PAUANUI ACCESSIBILITY AUDIT REPORT

Thames-Coromandel District Council (TCDC) has requested an accessibility audit for the Central Business District (CBD) area of Pauanui, with particular emphasis for disabled and elderly residents. The audit covers:

Figure 8: Mobility Space with blue surfacing design

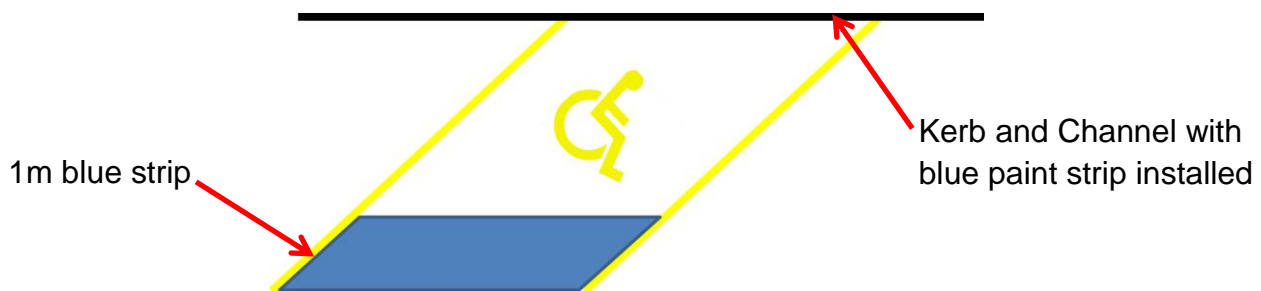
While full blue coverage is preferred for marking mobility parking spaces, in the interest of maintenance and costs, consideration could be given to only partially colouring the mobility space as shown in Figure 8.

A 1m strip for the length of the road edge of the carpark will provide visual notice to road users, reduce installation costs, and reduce the need for repair when replacing kerb and channel etc.

During the consultation process where this was suggested, concern was raised about visibility of the mobility parking space from the footpath. Installing a blue coloured metal plate or a blue strip on the top of the kerb will aid pedestrians to 'police' the spaces.

Recommendation 13 Continue the programme to mark Mobility Spaces with blue surfacing. Installing blue marking as per figure 8 will aid with maintaining a non-slip surface with the colour of both the surface and the marking to comply with Land Transport Rule: Traffic Control Devices 2004.

Figure 15: Old kerb ramp at Vista Paku/Pauanui Boulevard intersection

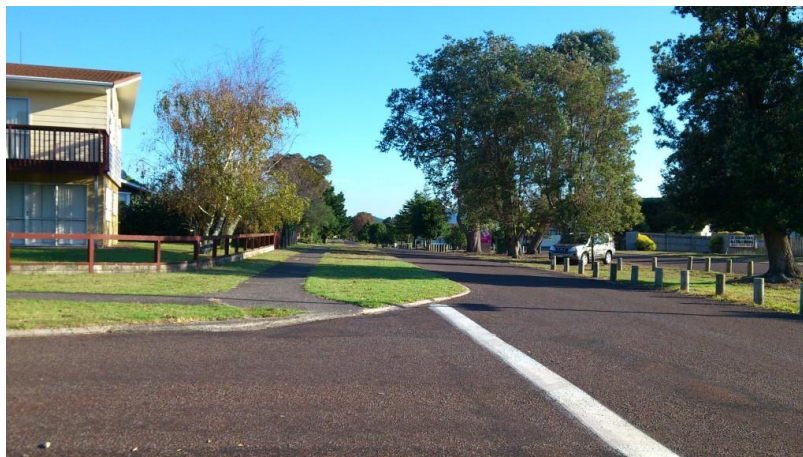
- Vista Paku/Pauanui Boulevard – Remove old kerb ramp to minimise the risk of visually impaired users crossing at the wrong location;

Figure 23: Preferred Layout of crossing points with Tactile Paving

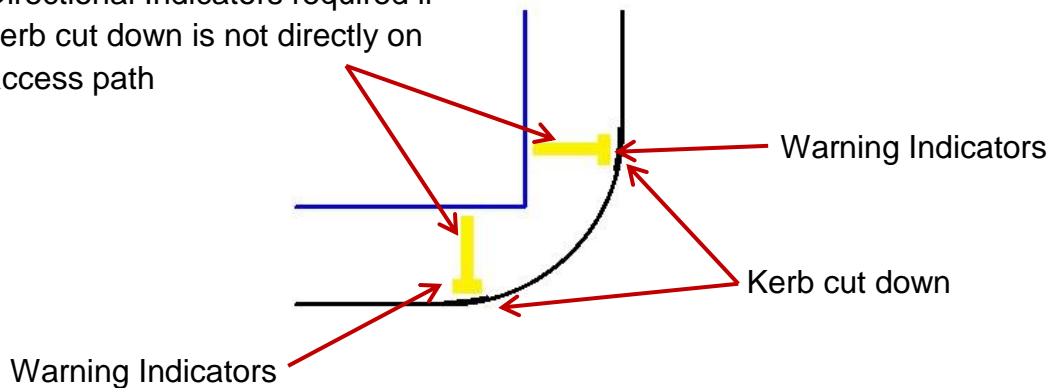
Directional Indicators required if kerb cut down is not directly on access path

- In conjunction with Warning Indicators where a road crossing point is not located in the continuous accessible path of travel and directional guidance is required; and
- Across the full width of the path, with a minimum depth of 600mm to indicate a change in direction of the continuous accessible path of travel.

Figure 48: Crossing Pauanui Boulevard at the Vista Paku/Hikuai Settlement Road intersection

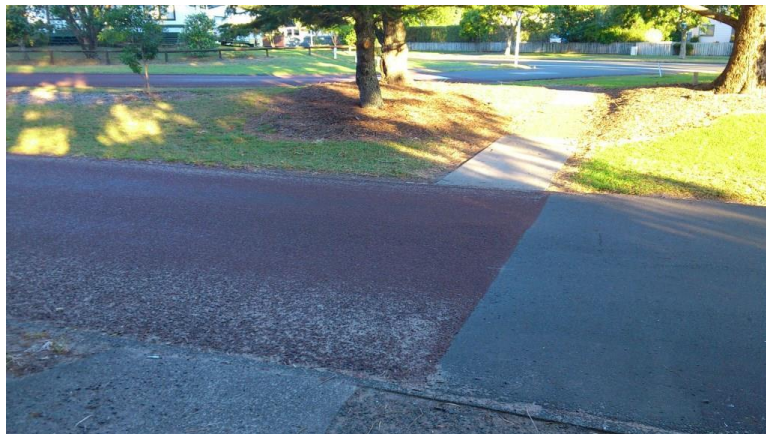
- Vista Paku/Hikuai Settlement Road – requires a 1.5m concrete path in the centre refuge;

Figure 53: Picnic tables blocking access from the Mobility Space at Pauanui Bakery

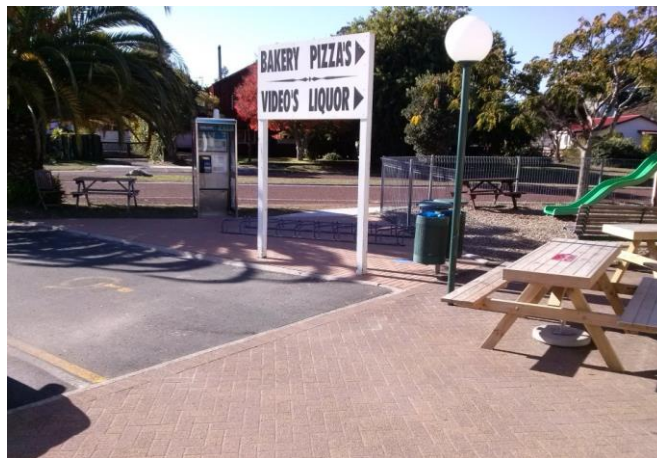
Al-fresco dining causes an access issue at the Pauanui Bakery. The location of the picnic tables makes it awkward for accessibility users to access the footpath from the Mobility Space.

Recommendation 55 Liaise with business owners to retain clear access route widths and keeping the building line clear of al-fresco dining furniture, signage and stock for sale.

Figure 58: Access to the Surf Club from Pauanui Boulevard

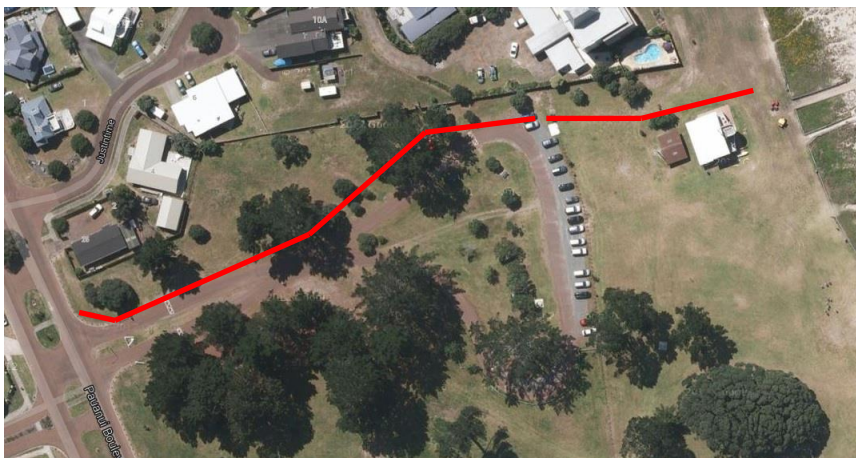
The Surf Club is situated opposite The Dunes on Pauanui Boulevard. Connecting a 3m path from Pauanui Boulevard to the carpark and the top of the grass reserve will provide good access in this location.
